Model: PRIPORT RUBY		Date: 12-Oct-04	No: M-C232-002
Modified Article: Paper Guide		Prepared by:	
From: Priport Service Planning Section		A. Yoshida	
Classification:	<input type="checkbox"/> Parts catalog correction	<input type="checkbox"/> Vendor change	<input type="checkbox"/> To meet standards
	<input type="checkbox"/> To facilitate assembly	<input checked="" type="checkbox"/> To improve reliability	()
	<input type="checkbox"/> Part standardization	<input type="checkbox"/> Other ()	
Model Name:			
Ricoh JP5800

The following applies to the optional JS40-Sorter.

Model: PRIPORT RUBY	Date: 3-Dec-04	No: M-C232-003
Modified Article: Belt drive motor	Prepared by:	
From: Priport Service Planning Section	M. Kanomata	
Classification:	<input type="checkbox"/> Parts catalog correction <input type="checkbox"/> Vendor change <input type="checkbox"/> To meet standards <input type="checkbox"/> To facilitate assembly <input checked="" type="checkbox"/> To improve reliability () <input type="checkbox"/> Part standardization <input type="checkbox"/> Other ()	
Model Name:		
Ricoh JP5600

Revised Illustration:

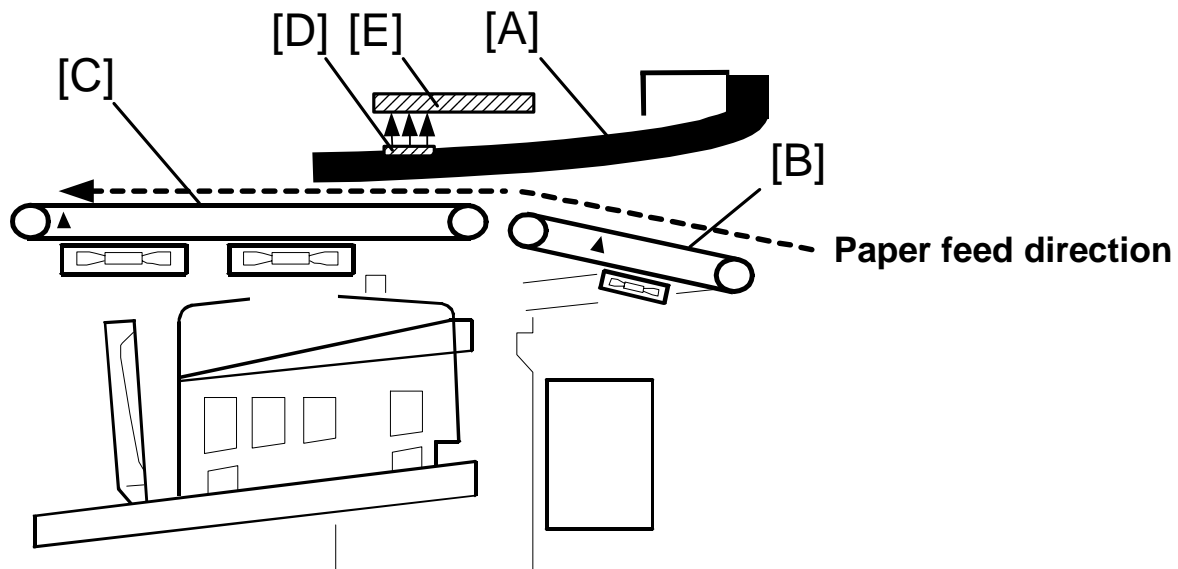
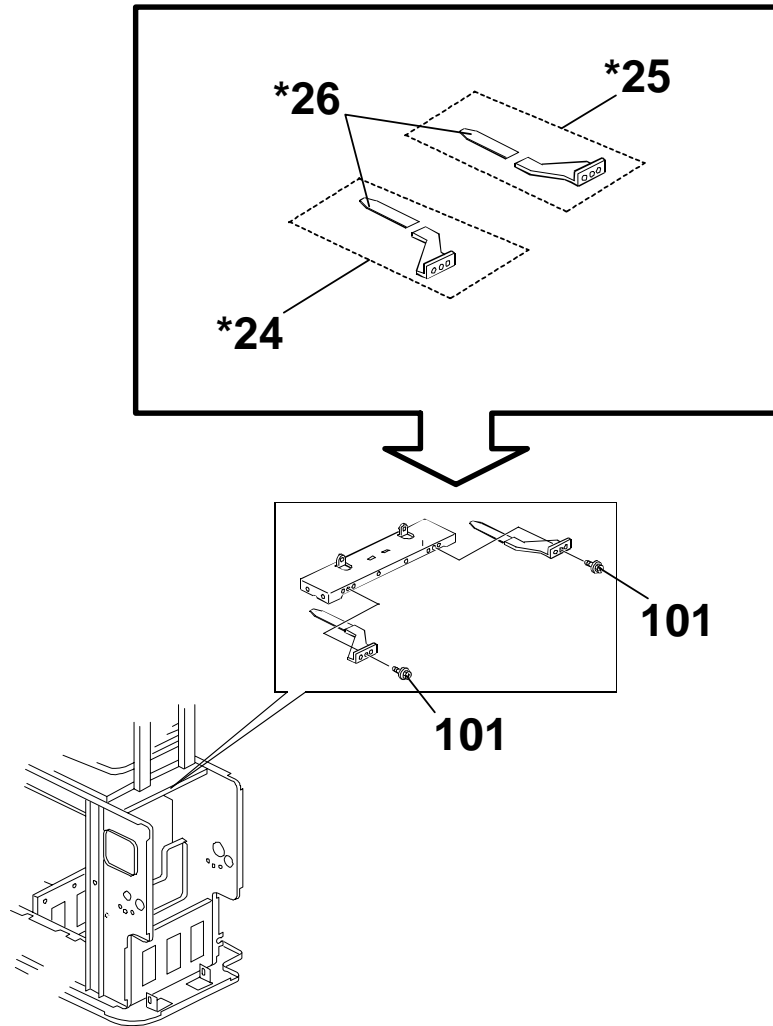
Change: Added front guide assembly [A], rear guide assembly.

Reason: To ensure that curled paper is fed smoothly in the relay transport area [B] and horizontal transport area [C].

Important: When images with many solid image areas are printed out often, light scratches can appear on the copy. For these customers, attach a piece of double-sided tape [D] to the guide assembly, and then attach the guide assembly to the upper stay [E].

Illustrations:

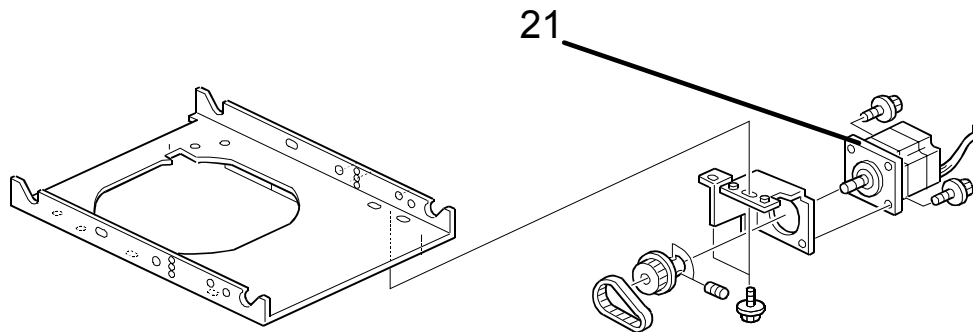
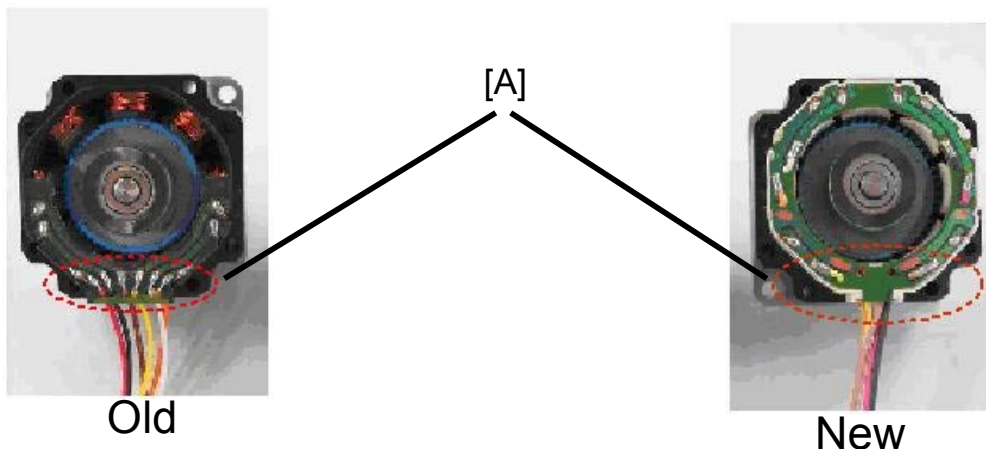
Change: The internal connection of the harness and motor was changed.

Reason: To ensure that the harness stays connected to the motor. This will ensure that a jam at the relay transport unit does not occur.

[A]: Internal connection point of the harness.
